CHANGE ORDER

No. 1 (Final)

| Contract: | Dunleith Canal Level Recharge System | |
| OWNER's Contract No. | P080502-4 | ENGINEER's Contract No. 2008-21-810 |

Pre-Site

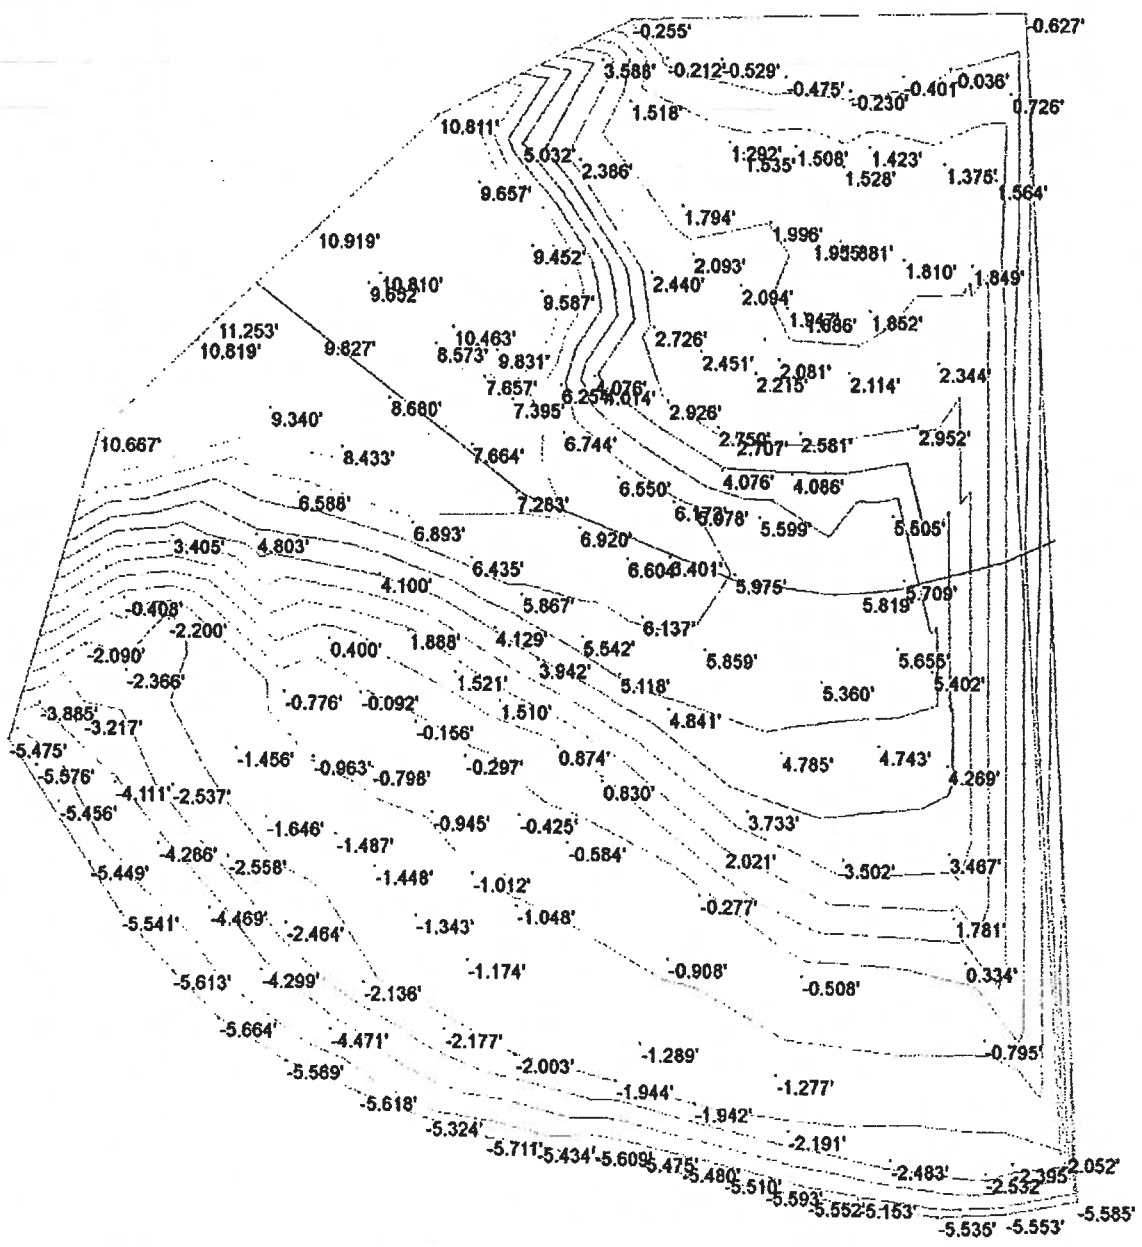
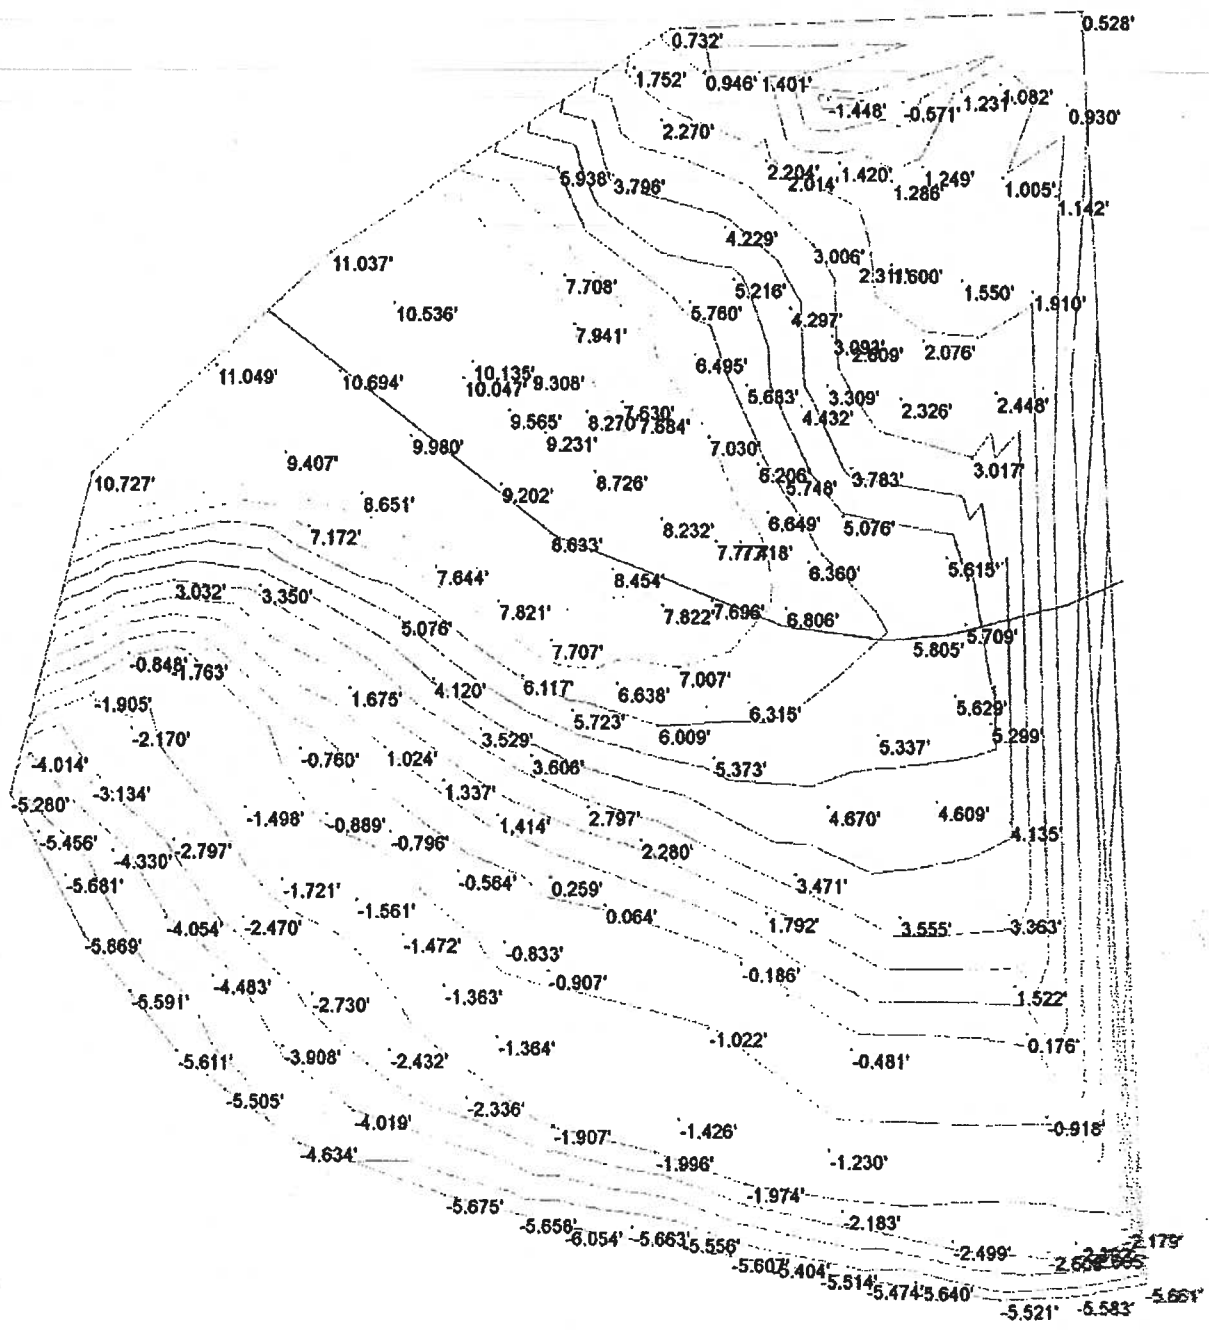
3. Revise Work Item Quantities
- a. Contract Item No. 3 The finished in-place quantity of embankment after placement and compaction was determined through pre-construction and post-construction surveys to be 240 CY. The estimated bid quantity from the design survey and the estimated final cross-section was 340 CY.

Total balanced volume : 183.060yd³ (Fill)

Total fill volume : 240.841yd³

Project: 1521 Dumbith Canal
Subject: Pipeline Shop Drawings (Pg. 1 of 1)
Date: 09Oct13 Scale: 1/4":1'
Prepared By: Lee Bourgeois, PVI

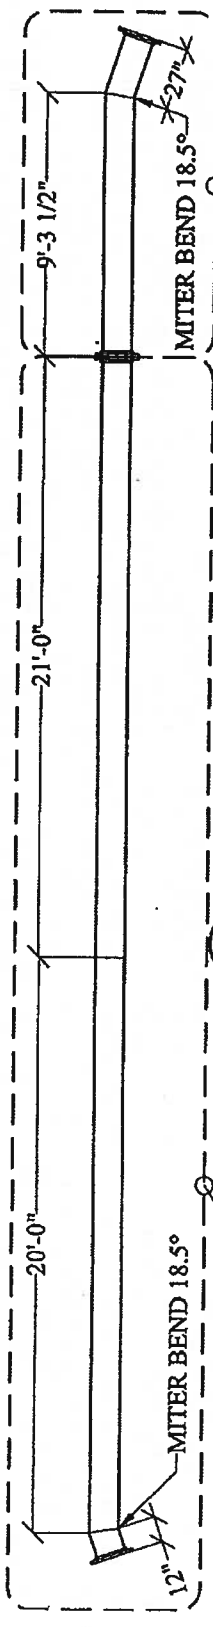
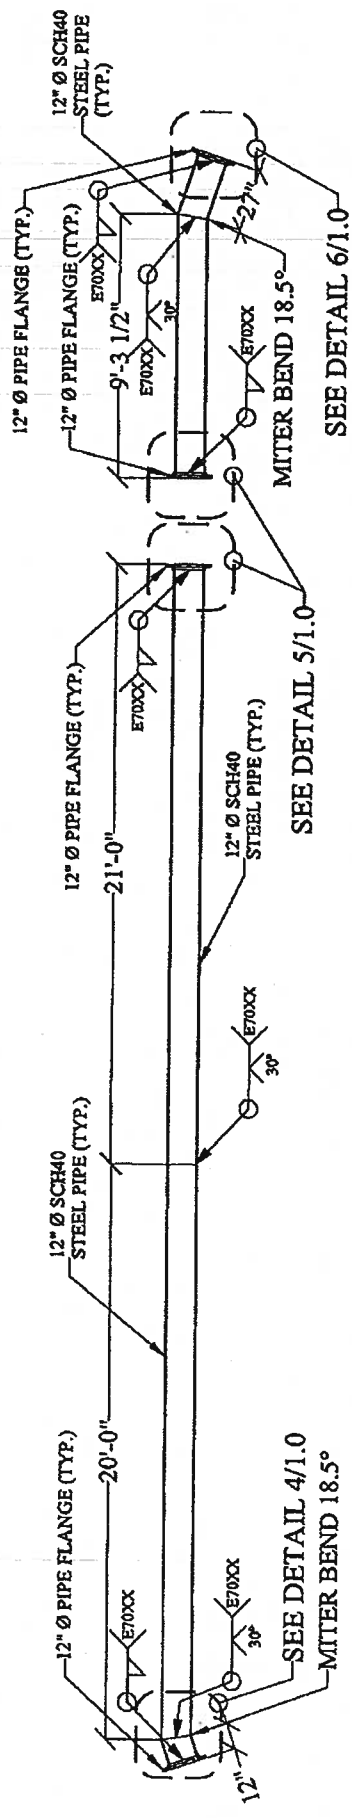
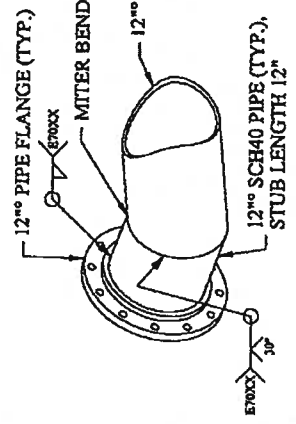
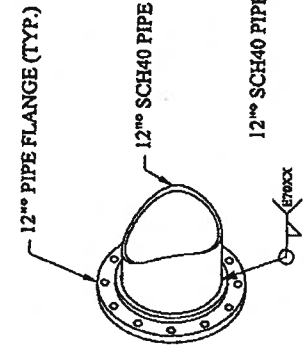
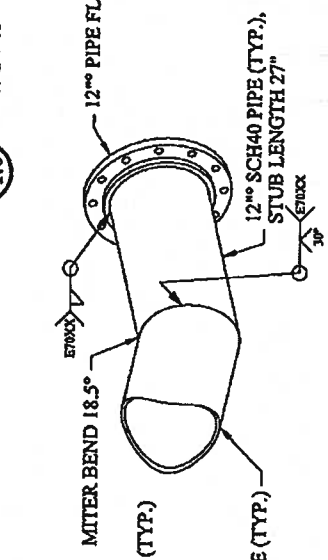
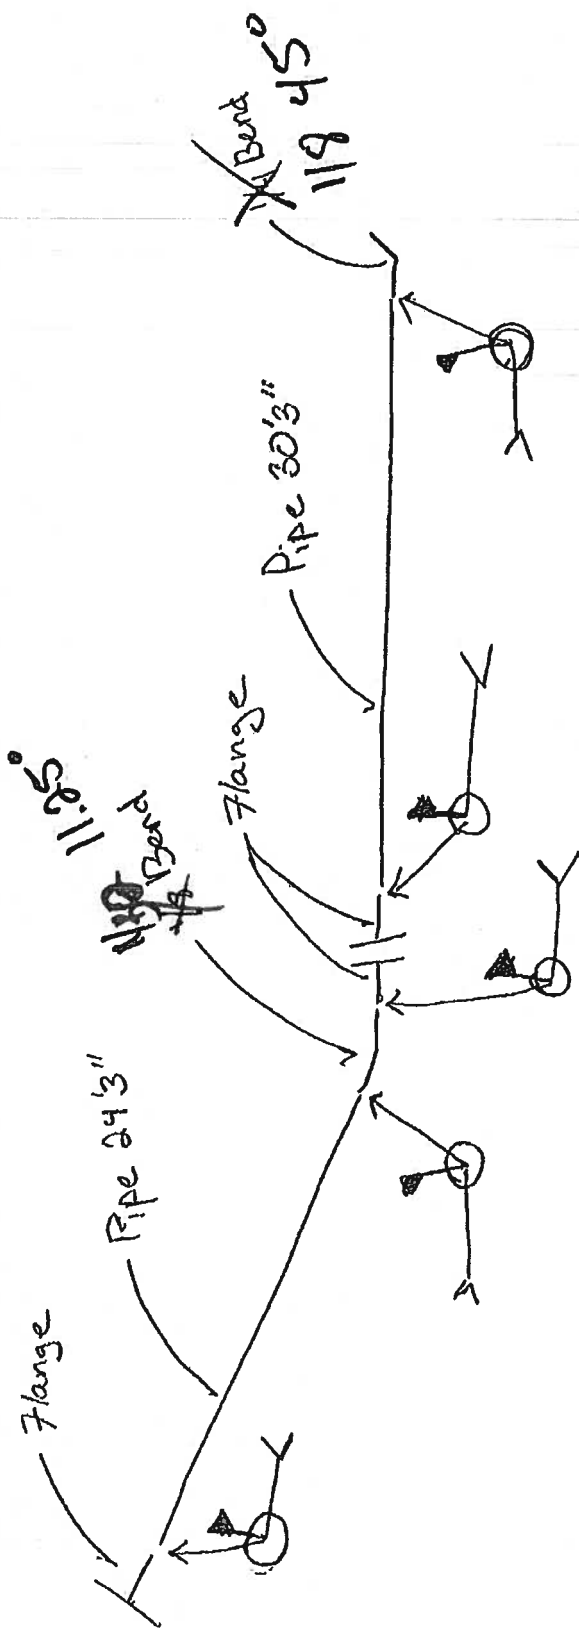
- b. Contract Item No. 4 19 LF of piping was added at the direction of the Engineer due to the change in alignment resulting from field conditions, levee profile, and sump area to minimize erosion and disturbance of existing ground.

| Line | Description | Unit | Unit Price | Qty | Cost | Positive | Negative |
|------------------------------|---|------|--------------|---------|----------------|--------------|--------------|
| 2 | Additional pipe needed for revised levee profile | LF | \$ 197.00 | 19.00 | \$ 3,743.00 | \$ 3,743.00 | |

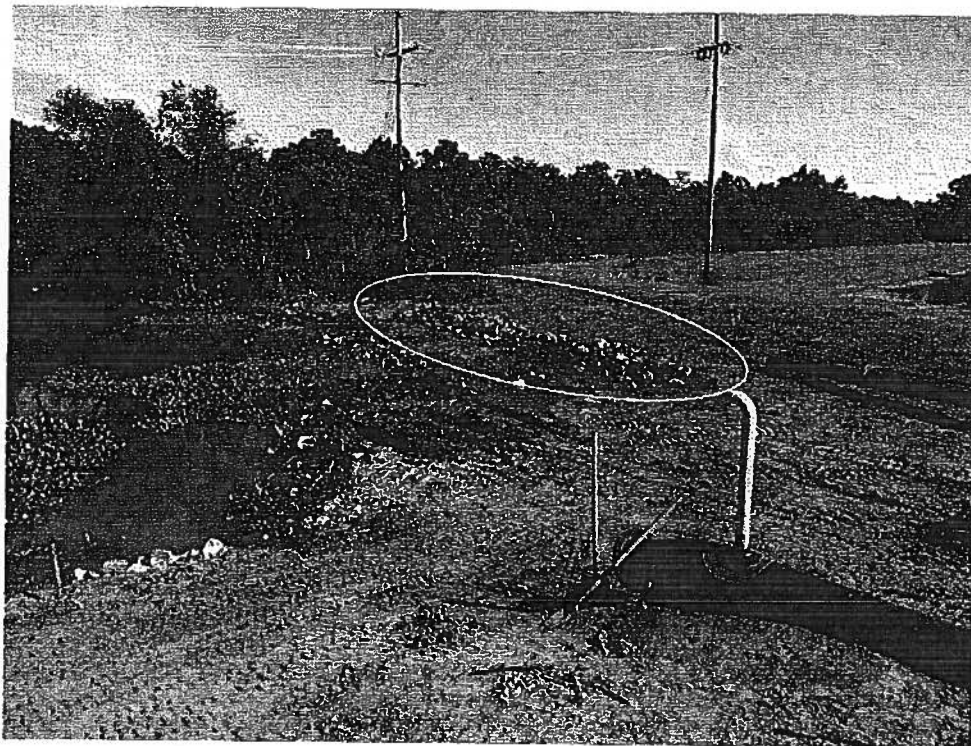
Contacted Pontchartain Materials to price rip-rap that was specified for this project. Spoke with Steve, (504) 274-1654, and was quoted a price of \$40.00/ton. At the conversion rate of 1.4 tons/CY; the mass of the rip-rap that Volute salvaged from the Owner's property through the grubbing & clearing process, which is conservatively estimated to be 12CY, calculates to 16.8 tons. With the applicable taxes this would equate to a credit of \$732.48 to be extended to the Owner.

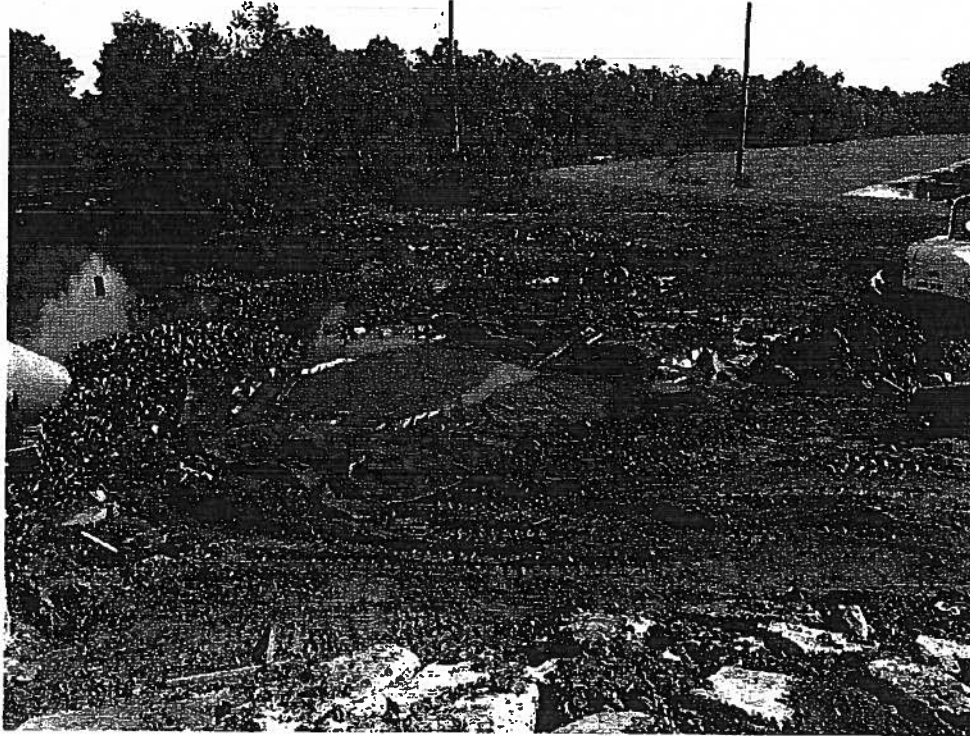
An additional quantity of 80 SY of geotextile fabric was installed in the new sump pit. This quantity is comprised of two (2) pieces of fabric each of a length of 24 LF and the fabric has a stock width of 15 LF.
